Intel[®] Mobile Pentium[®] III Processor Specification Update

Release Date: April 2000

Order Number: 245306-006

Figure 7. BCLK Timing Waveform

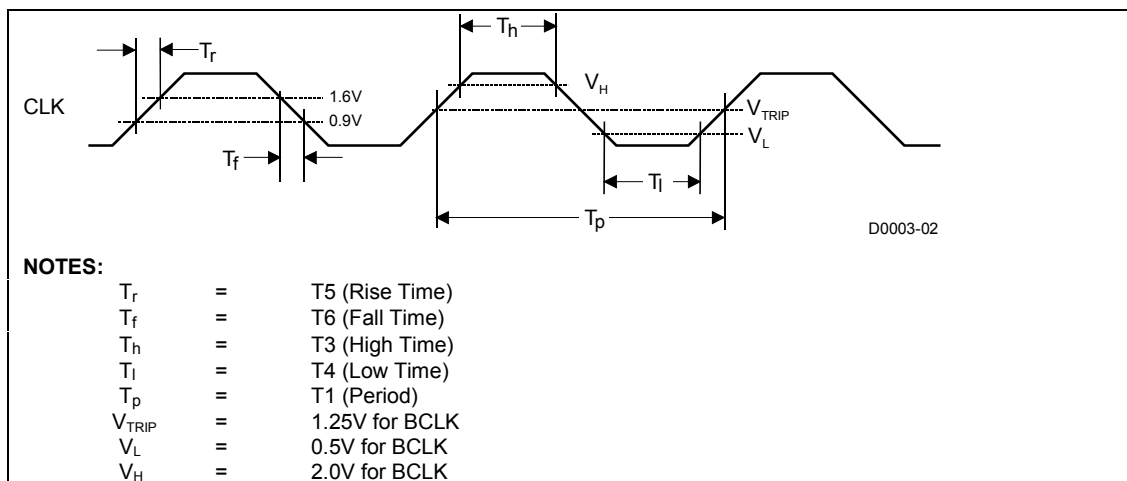
The BSEL[1:0] signals for B0 step are specified to be 3.3V tolerant. This is in contrast to 1.5V tolerance specified for these signals in A2 step processors. This modification does not involve any change in $V_{CMOSREF}$ and will not affect current designs. This modification affects the corresponding specs in Table 8 and Table 13 in *Mobile Pentium® III Processor in BGA2 and Micro-PGA2 Packages datasheet*.

For B0 step processors, the $V_{IH,BCLK}$ Min spec is changed to 2.0V (from 1.7V for A2 step) and $V_{IL,BCLK}$ Max spec is changed to 0.5V (from 0.7V for A2 step). Due to this, new values are specified for BCLK high and low times for B0 step processors. These modifications affect corresponding specs in Table 13, Table 14, Table 24, and Figure 7 in *Mobile Pentium® III Processor in BGA2 and Micro-PGA2 Packages datasheet* (Order Number 245302-002).

The following tables and figures highlight the above mentioned BSEL[1:0] and BCLK specs modifications made for B0 step processors:

| Symbol | Parameter | Min | Typ | Max | Unit | Figure | Notes |
|--------|-----------------------|-------|-----|-----------|------|----------|---------------|
| T3 | BCLK High Time | 2.70 | | | ns | Figure 7 | at >2.0V |
| T4 | BCLK Low Time | 2.45 | | | ns | Figure 7 | at <0.5V |

Figure 4. BCLK Waveform at the Processor Core Pins

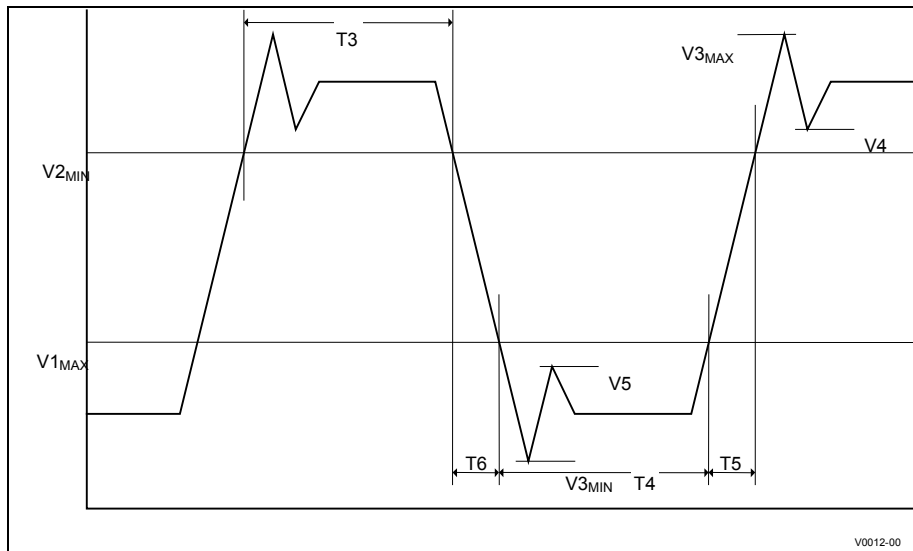
In Table 18, “BCLK Signal Quality AC Specifications at the Processor Core” of the *Intel® Pentium® III Processor Mobile Module: Mobile Module Connector 2 (MMC-2)* datasheet, and Table 19 of the *Intel® Pentium® III Processor Mobile Module: Mobile Module Connector 2 (MMC-2) Featuring Intel® SpeedStep™ Technology* datasheet, Note 3 has been updated. Figure 4 “BCLK Waveform at the Processor Core Pins” has also been updated. See below.
